Office Action Summary

10/812,907

Michael P. Ferguson

DETAILED ACTION

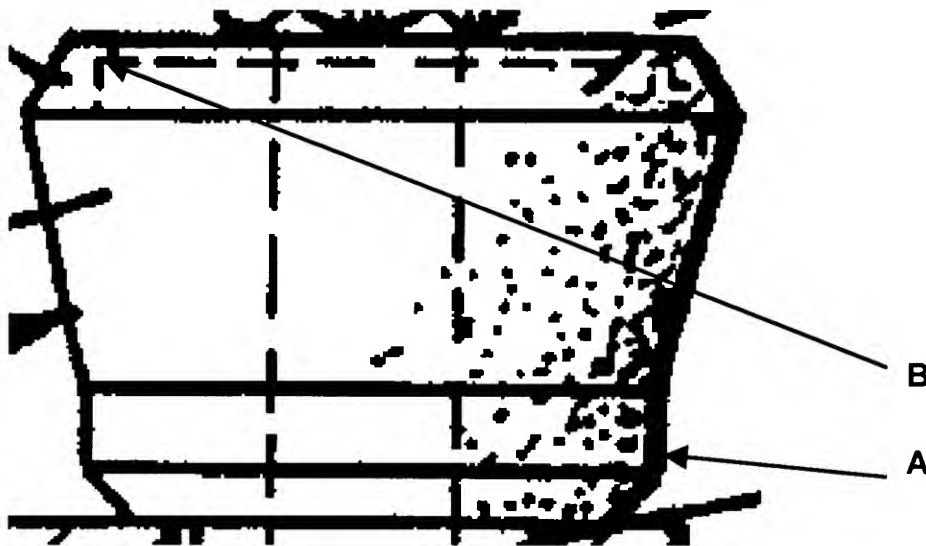
As to claim 28, Hardy, Jr. et al. disclose a grommet suitable for use in a link for connecting a pair of spaced members **102,108** having a set of aligned holes, together, generally including a bolt **112,122** having a pair of spaced upset portions **126,128**, a pair of inner **138,140** and outer **134,136** grommets disposed at each end of the bolt, engaging therebetween one of the members, and retainer means **120,132** disposed on the ends of the bolt, comprising a body formed of a resilient material having a bore for receiving the bolt therethrough, the wall of the bore having an annular groove allowing the body to be snap-fit onto an upset portion of the bolt when mounted thereon, and a rigid washer insert **A** (Figure 3 reprinted below with annotations) molded in the body disposed adjacent the groove and having an opening aligned with the bore (Examiner notes that a specific location of the washer insert relative to the groove and the upset portion is not claimed. Examiner notes that the claim does not positively claim that the washer insert is located in the bore adjacent the groove, nor that the washer insert engages the upset portion; Figures 3-4, column 2 lines 47-49).

As to claim 18, Hardy, Jr. et al. disclose a link wherein each of the outer grommets **134,136** includes a bore for receiving the bolt **112,122** therethrough, and the wall of the bore is provided with a protrusion **B** engageable with the bolt **122** extending through the bore, functional to permit the outer grommet to be temporarily frictionally

held on an end of the bolt for shipping purposes (protrusion **B** frictionally engages bolt **122**; Figure 3).

As to claim 19, Hardy, Jr. et al. disclose a link wherein the protrusion **B** has an annular configuration, protruding radially, inwardly into the bore (Figure 3).

Examiner disagrees. As to claims 1,20 and 54, Hardy, Jr. et al. disclose a link comprising a bolt **112,122** having a pair of upset portions **126,128** spaced inwardly relative to the end portions (elements **126,128** project radially outward from bolt **112,122** and thus define upset portions. Examiner notes that no specific structure of the upset portions has been claimed.); and a pair of inner grommets **138,140** having a portion functional to snap-fit (frictionally engaged) on one of the upset portions of the bolt (Figure 3).

Examiner disagrees. As to claims 4,9,20 and 28, Hardy, Jr. et al. disclose a link comprising a pair of inner grommets **138,140** each having a washer insert **A** molded therein, and the washer, and a groove in the bore permitting the inner grommet to be snap-fit onto an upset portion of the bolt with the upset portion being received in the groove when the inner grommet is mounted on the bolt with the bolt extending through the bore (Examiner notes that a specific location of the washer insert relative to the groove and the upset portion is not claimed. Examiner notes that the claim does not positively claim that the washer insert is located in the bore adjacent the groove, nor that the washer insert engages the upset portion); and a pair of outer grommets **134,136** each having a washer insert **A** mounted therein, and the washer and a groove in the bore permitting the outer grommet to be snap-fit onto a flanged portion **132** of one of the nuts (Examiner notes that a specific location of the washer insert relative to the groove and the flanged portion is not claimed. Examiner notes that the claim does not positively claim that the washer insert is located in the bore adjacent the groove, nor that the washer insert engages the flanged portion; Figure 3).

Examiner disagrees. As to claim 18, Hardy, Jr. et al. disclose a link wherein the wall of the bore of each of outer grommets **134,136** is provided with a protrusion **B** engageable with the bolt **122** extending through the bore, functional to permit the outer grommet to be temporarily frictionally held on an end of the bolt for shipping purposes (protrusion **B** frictionally engages bolt **122**; Figure 3).
